HENDERSON COUNTY PLANNING BOARD

SUBJECT: Revised Master Plan for The Sanctuary Subdivision
(2017-M01) (December 2017 Revised Master Plan)

Henderson County Planning Department Staff Report

**Revised Master Plan
The Sanctuary at Eagles Nest-Horseshoe Farm (2017-M01)**

Master Plan Comparison

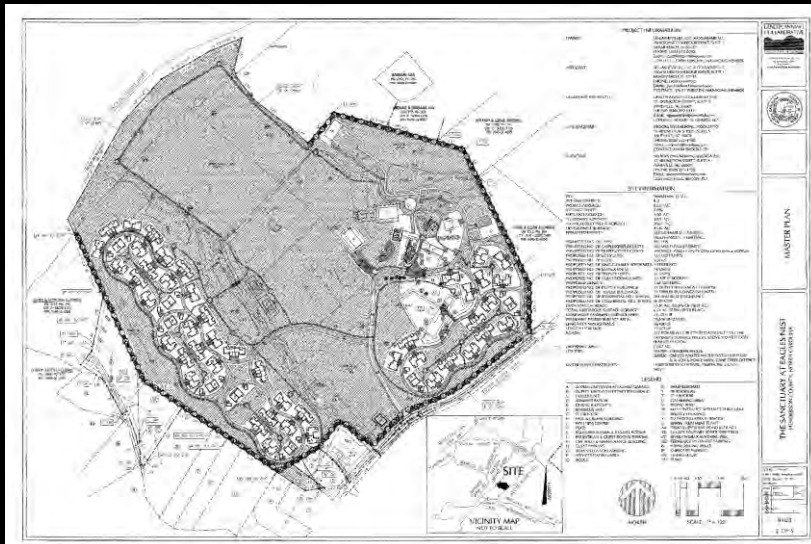
- **Master Plan Revisions:** Duplex units reduced by 42 and triplex units reduced by 30. Revised plan includes three single-family dwellings (The homes already exist on the property. Original plan proposed their removal). Density is reduced by .77 and open space is still around 69%
- **TIS:** The applicant will still be required to install turn-lane at main entrance.
- **Approval of Master Plan:** The applicant is seeking approval of a revised master plan. If approved, a development plan must be submitted within two years (January 2020). Master Plan approval would expire if no development plan is submitted. Conditions noted in staff report (including sewage treatment) as well as traffic impact requirements would all need to be completed before development plan approval.
